STAFF REVIEW AND RECOMMENDATIONS  
PUBLIC HEARING  
MARCH 4, 2020

PRELIMINARY PLAT:        BROOKWOOD COMMERCIAL PARK

REVIEWED BY:                AMY OTTO-BUCHANAN                                CASE #: 2020-010

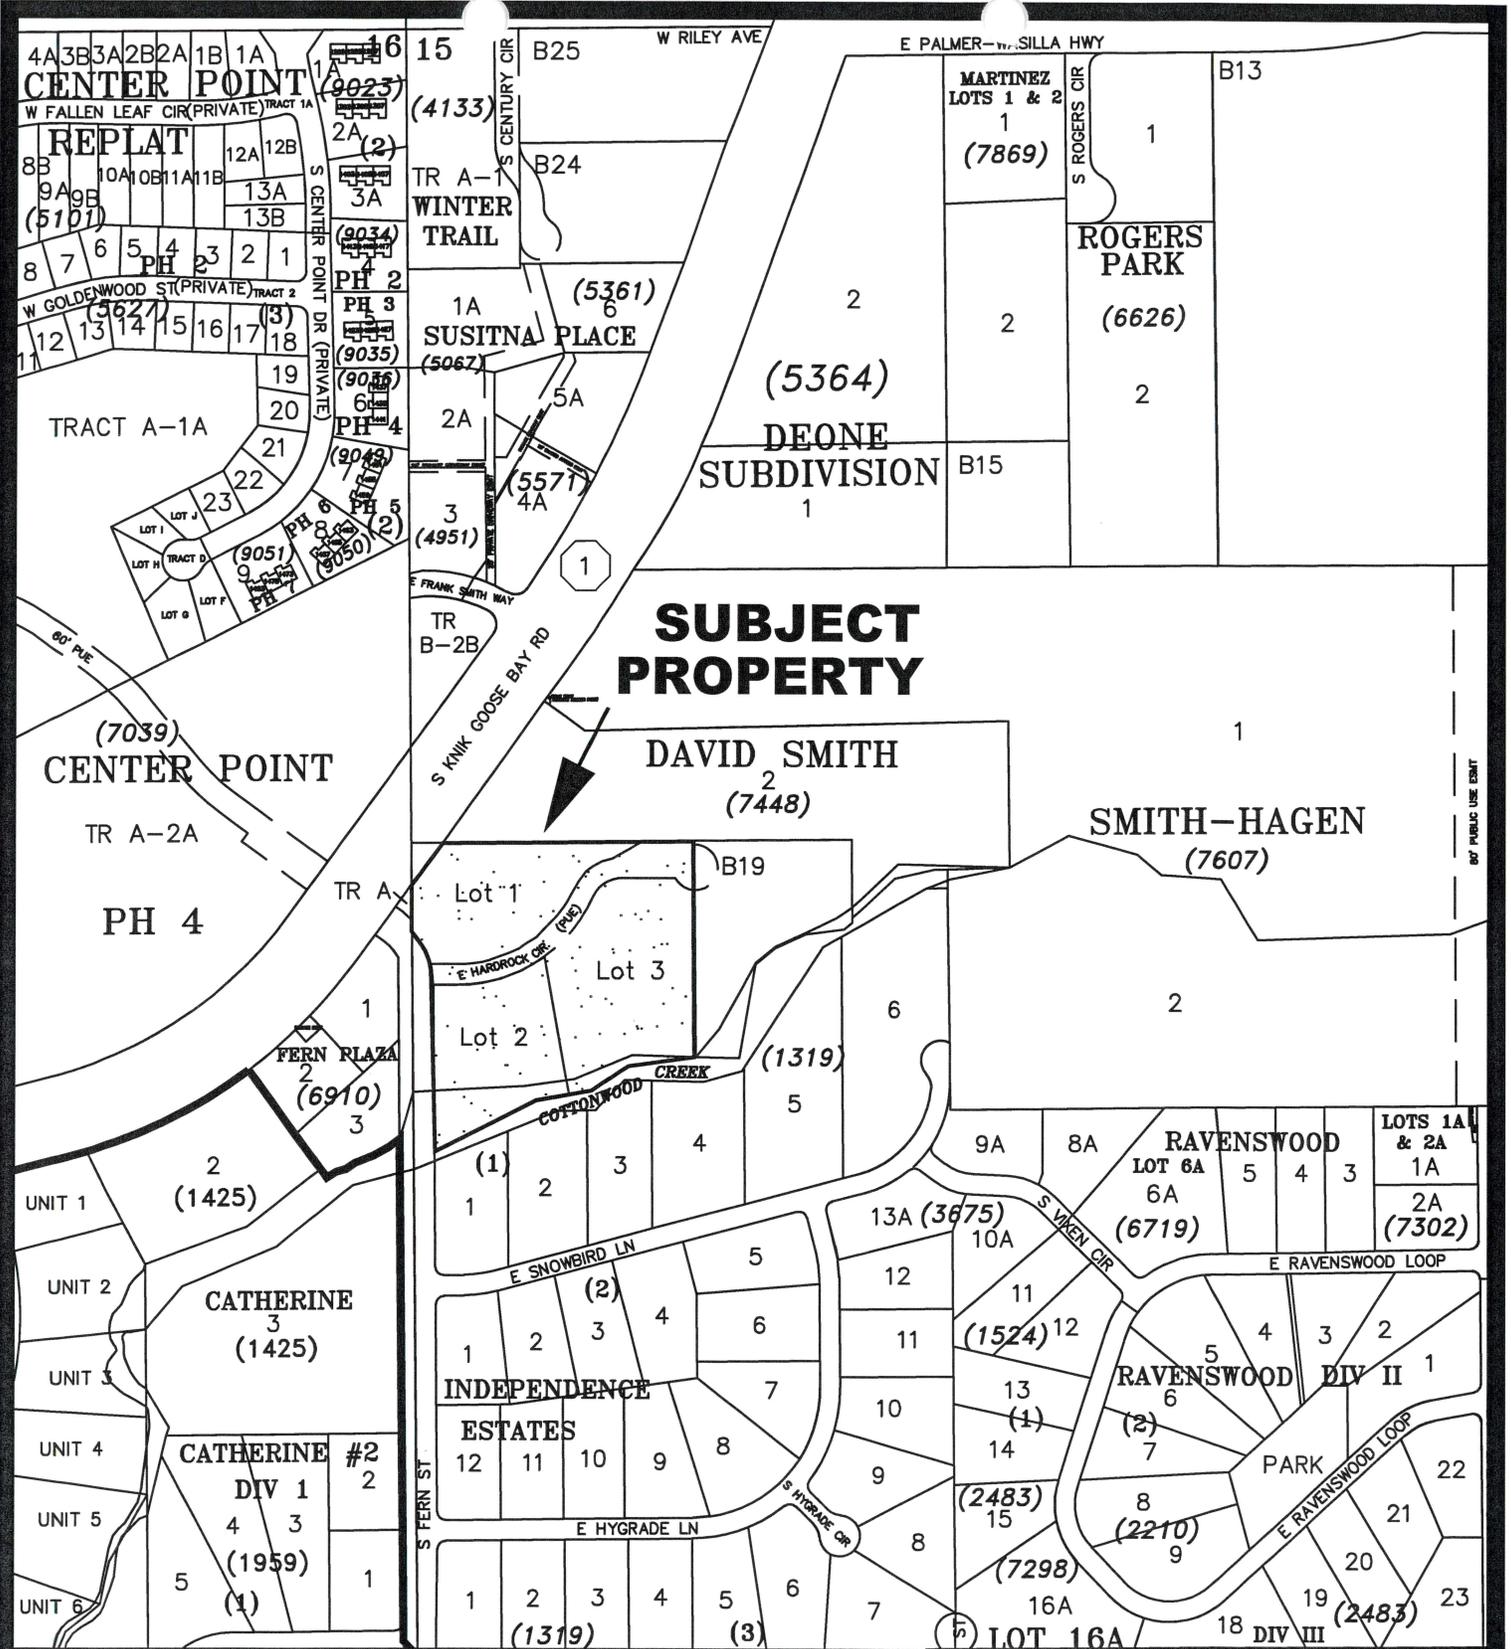
**Comments:** Department of Public Works Operations & Maintenance (**Exhibit C**) has no comments. Department of Emergency Services (**Exhibit D**) notes the agenda plat does not show a cul-de-sac at the end of the created road. The Request for Comments does. Dead end roads create a particular hardship for emergency vehicles; requiring them to either back into the road or back out. *Staff notes there is a cul-de-sac at the end of E. Hardrock Circle PUE, the majority of it is on Tax Parcel B19 to the east. This PUE is not constructed other than a driveway that accesses Tax Parcel B19. Lot 3 is a flag lot, the flag is within the PUE. Petitioner will be constructing a portion of E. Hard Rock Circle from S. Fern Street east approximately 100' to City of Wasilla street standards. Lot 1 and Lot 2 will take physical access from E. Hard Rock Circle.* Planning Division (**Exhibit E**) has no comments.

**Utilities:** (**Exhibit F**) MEA requests a 15' wide utility easement adjoining the south right-of-way of E. Hard Rock Circle. *Staff notes an abbreviated plat cannot grant easements; the easement may be created by*

**ADOT&PF:** (Exhibit G) states no direct access will be granted to S. Knik-Goose Base Road. All access must be to E. Hard Rock Circle.

**City of Wasilla:** (Exhibit H) notes the applicant will need to apply for a Land Use Permit for Subdivision to the City (see *Recommendation #7*). Public Work Department notes the cul-de-sac at the eastern end of E. Hard Rock Circle needs to be shown on the plat.

Amy,  
The agenda plat does not show a cul-de-sac at the end of the created road. The RFC does. Dead end roads create a particular hardship for emergency vehicles; requiring them to either back into the road or back out.

The cul-de-sac that is called out at the eastern end of E. Hard Rock Circle needs to be shown.

Don: There is a cul-de-sac at the end of E. Hardrock Circle PUE, the majority of it is on the parcel to the east. This PUE is not constructed other than a driveway that accesses B19 to the east. Lot 3 is a flag lot, the flag is within the PUE. Petitioner will be constructing a portion of E. Hard Rock Circle from S. Fern Street east approximately 100' to City of Wasilla street standards. Lot 1 and Lot 2 will take physical access from E. Hard Rock Circle. Thanks & have a good weekend. A.

Brookwood Commercial Park  
Useable Area, Drainage, and Topography Map

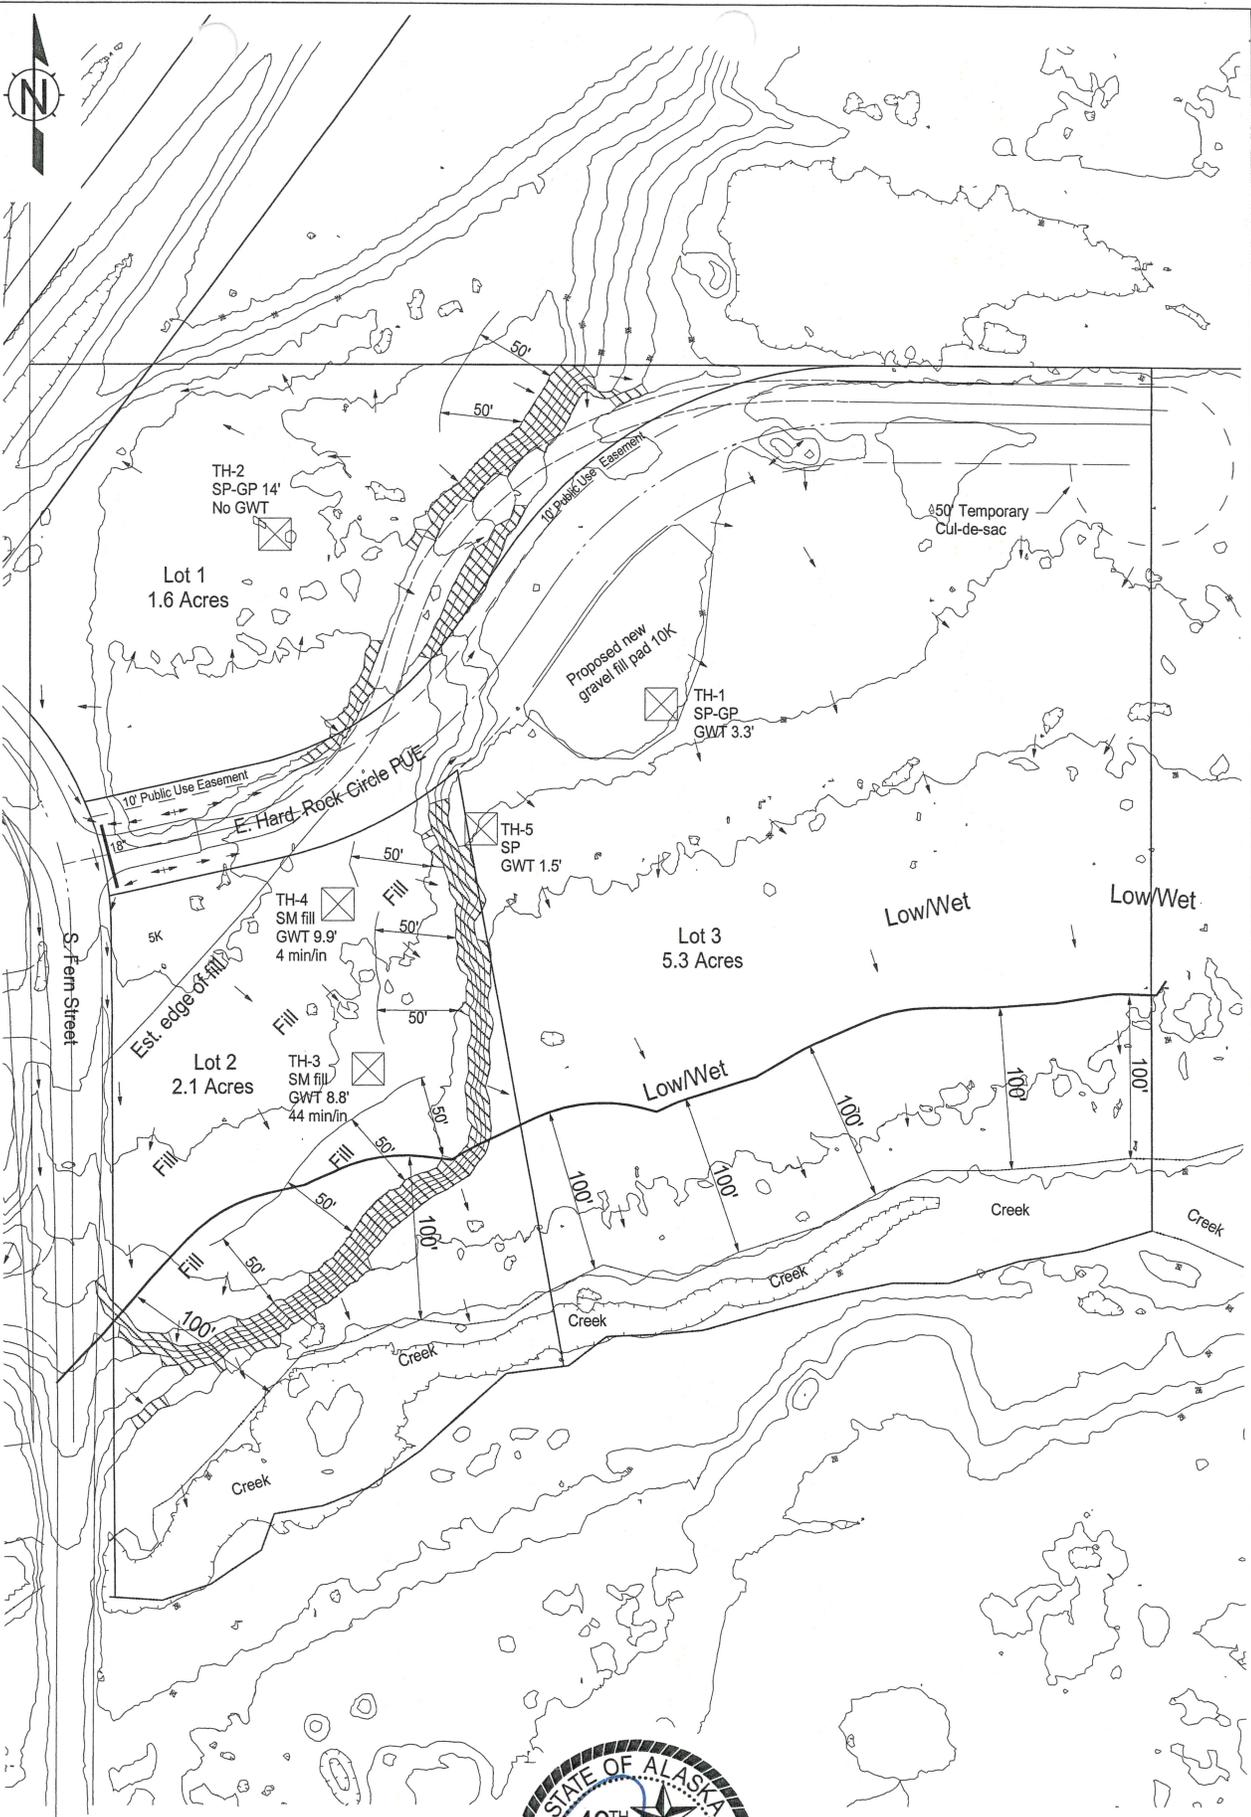
**SOILS:** Geotechnical report, submitted per MSB 43.20.281(A) at **Exhibit B**. Curt Holler, PE, Holler Engineering, notes the soils evaluation included logging five new testholes, observing an open cut bank face, review of an existing testhole, review of provided topography information, review of aerial imagery, and observations on site. Testhole location/topography map and testhole logs attached. Parcels is bordered by S. Fern Street, with a short section along S. Knik-Goose Bay Road; it’s southern boundary is formed by Cottonwood Creek. Terrain consists of two distinct regions of higher and lower ground. Drainage is directed southward or to low areas within the project as shown on the attached map. Total elevation

differential is approximately 24'. Several areas containing steep slopes exceeding 25% were found and are delineated on the attached map. Much of the parcel is undisturbed with the exception of the right-of-way clearing for E. Hard Rock Circle. Testholes were dug to a depth of 12' or to 2' beyond encountered groundwater. In undisturbed areas, native soils included an organic mat over silty loess topsoils above sands with gravel receiving soils. An area of approximately 1.2 acres on proposed Lot 2 has been filled with non-native silty sands with gravel and mixed debris or organics such as roots and small logs. The two testholes dug in this area were similar in type and amount of organics or non-soil debris, estimated at around 5% overall. Based on the age of trees along the edge and top of the fill, it was placed many decades ago. Aerial images from 1949 show the areas as then-recently cleared. Percolation tests were conducted in both the fill area testholes, with absorption rate of 4 and 44 minutes per inch. Groundwater was noted in all but one of the newly logged testholes. Cottonwood Creek and low lying areas border the southern edge. Groundwater was encountered in three of the new testholes. Groundwater was found in testholes #1, #3, #4, & #5 at respective depths of 3.3', 9.9', 8.8', and 1.5'. Proposed Lot 3 does not presently have any area with over 8' to groundwater. Based on available soils and water table information, topography, MSB Code and observations on site, Lot 1 contains over 10,000 sf of contiguous useable septic area and an additional 10,000 sf of useable building area. Proposed Lot 2 will have over 10,000 sf of contiguous useable septic area, subject to verification of water table in the spring (see **Recommendation #5**), and an additional 10,000 sf of useable building area. Proposed Lot 3 has no useable septic area presently and will require 10,000 sf of useable area created by filling to meet the requirement for 8' separation to groundwater (see **Recommendation #5**). If the fill is placed, Lot 3 will also contain an additional 10,000 sf of building area. Alternately, Lot 3 can be combined with Lot 2 by removing the common lot line.

**Road Construction and Drainage Plan:** An existing driveway is roughly within the existing Public Use Easement (PUE) of S. Fern Street; however the project will require construction of a short section (100') of road to provide access to proposed Lot 1 and Lot 2. Based on the small size of the project, base and topping materials would likely be imported. The road improvements will improve but minimally impact existing overall drainage patterns. A single corrugated metal 18' culvert is planned across the new road stub to maintain original flow patterns. General drainage patterns are indicated on the attached map.

3. Pay postage and advertising fees.
4. Show all easements of record on final plat.
5. Provide updated soils report for proposed Lot 2, subject to verification of water table in the spring. Updated soils report shall include confirmation of 10,000 sf of contiguous useable septic area after fill has been placed.
